Access Compliance Report Public Rights-of-Way (Curb Ramps)

Intersection ID: 10037049 Main Street: S_TRYON_ST Cross Street: N/A Location: NW

ADA ID: 5C7D5A53DABD Ramp Type: BlendTrans2 Initial Pass/Fail: Fail Overall Compliance: No Severity Score: 33.75

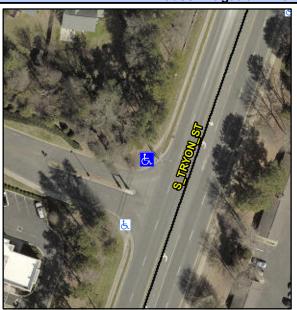
PROW/ADA:
Not Found, R304.5.1, R304.5.3

Compliance Description Data Compliance Description Data Yes N/A Ramp Length (in) 139.0 BlendTrans Slope (%) 3.3 39.0 No No Ramp Width (in) BlendTrans XSlope (%) 7.0 N/A N/A Flare Type LT N/A Flare Type RT N/A N/A Flare Slope LT (%) N/A N/A Flare Slope RT (%) N/A N/A Flare Traversable LT? N/A N/A Flare Traversable RT? N/A N/A N/A N/A **DWS Provided?** N/A Landing Length (in) N/A Landing Width (in) N/A N/A **DWS Contrast?** N/A N/A N/A N/A Landing Slope (%) DWS Length (in) N/A N/A Landing X Slope (%) N/A N/A DWS Full Width? N/A N/A Landing Curb? (Y/N) N/A N/A DWS Offset (in) N/A N/A N/A Shared Landing? N/A **Gutter Ponding?** N/A N/A Gutter Slope (%) N/A N/A Gutter Lip Ht (in) N/A N/A Gutter X Slope (%) N/A N/A Painted X Walk1? No N/A Painted X Walk2? No X Walk 1 Direction To S X Walk 2 Direction To E N/A X Walk 1 Width (in) X Walk 2 Width (in) N/A X Walk 1 Slope (%) 4.7 X Walk 2 Slope (%) 1.4 X Walk 2 X Slope (%) X Walk 1 X Slope (%) 1.5 3.3 N/A N/A Ramp inside XWalk2? N/A N/A Ramp inside XWalk1? Road Slope (%) 0.0 Clear Space? N/A N/A Road X Slope (%) Clear Space to XWalk (in) N/A 6.0 N/A N/A N/A Any Obstructions? Storm Grate/Utility Hazard? N/A Obstruction Type Storm Grate/Utility Type N/A N/A Yes Surface Condition? (G/P) Good

Remove & Replace Curb Ramp With
Two New Directional Ramps or
Equivalent.
